# ADDENDUM NO. 3 TO TUCSON AIRPORT AUTHORITY TUCSON INTERNATIONAL AIRPORT

## DBB1 – End Around Taxiway TAA Project No. 1011910210119102 AIRFIELD SAFETY ENHANCEMENT (ASE) PROGRAM DESIGN BID BUILD 1 SERVICES

April 27, 2021

WATERL SHEET REFERENCE NUMBER: EXHIBIT 1

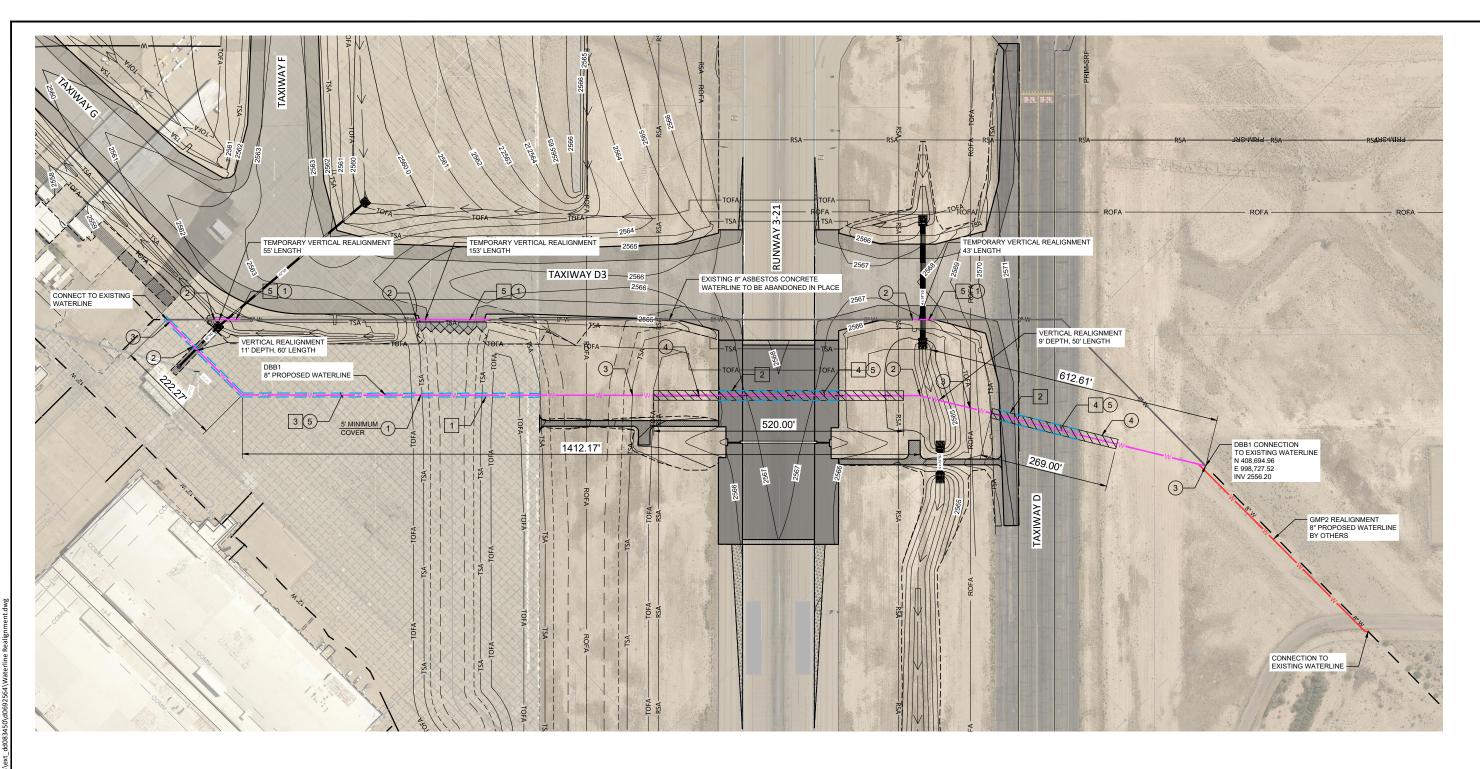
- 1. Exhibit 1 Waterline Realignment: This conceptual drawing supplements the proposed Tucson Water Plans by adding the permanent realignment of the 8" waterline as shown in Exhibit 1 and constructing three temporary vertical realignments of the existing 8" waterline to accommodate phasing. The successful bidder will be provided final (approved) Tucson Water Plans that will include realignment profiles and details for connecting to existing infrastructure. Exhibit 1 complements the proposed Tucson Water Plans and their associated quantities:
  - a. Remove-replace PCCP and AC pavement identified for pipe trenching Remove 375 SY PCCP Remove 232 SY AC Install 236 CY Aggregate Base Course Install 132 Ton Asphalt Surface Course Install 165 Ton Asphalt Base Course

- b. Protect in place the existing 8-Inch Asbestos Concrete Pipe until the completion of the realignment on Exhibit 1, when this line can be abandoned in place (or removed if conflicting with construction).
- Install pipe casing for RW and TW D crossings using open-cut construction.
   Install 789 LF 22-Inch Steel Pipe Casing
  - i. Original line item quantified in AIP Additive Alternate #2 to be removed. Line item included in Base Bid.
- d. Install realigned waterline
  Install 2,523 LF 8-Inch DIP Waterline
  Install 4 EA 8-Inch Gate Valve, Box & Cover
  Install 5 EA 1-Inch Air Release Valve (ARV)
